RE: Field Issues of over notched and over bored hole for Lot #1 Osage – 2108 SW Holdbrooks Dr. Lee's Summit, MO 64082 – Permit # PRRES20215066

Unit 2106 - Over notch in floor joist:

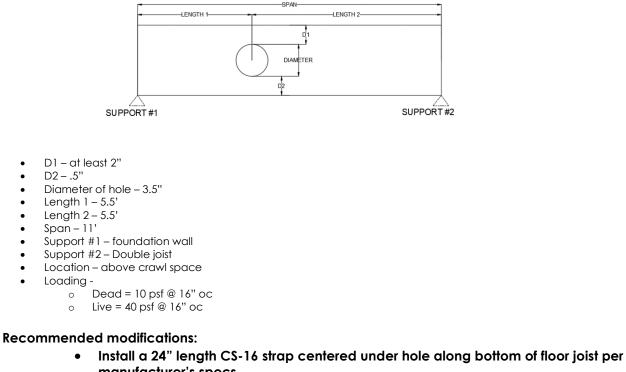
- D1 5"
- D2 4"
- Length 1 4'
- Length 2 7'
- Span 11'
- Support #1 Rear garage load bearing wall
- Support #2 garage steel beam
- Location above garage

- Install (2) DFL#2 2x10 as close as possible to over notched floor joist spanning approximately 11'.
- D1 5"
- D2-4"
- Length 1 1'
- Length 2 10'
- Span 11'
- Support #1 Rear garage load bearing wall
- Support #2 garage steel beam
- Location above garage

• Sister a 6' length DFL #2 2x10 to over notched floor joist with 4 fasteners per linear ft in a "w" pattern and glued.
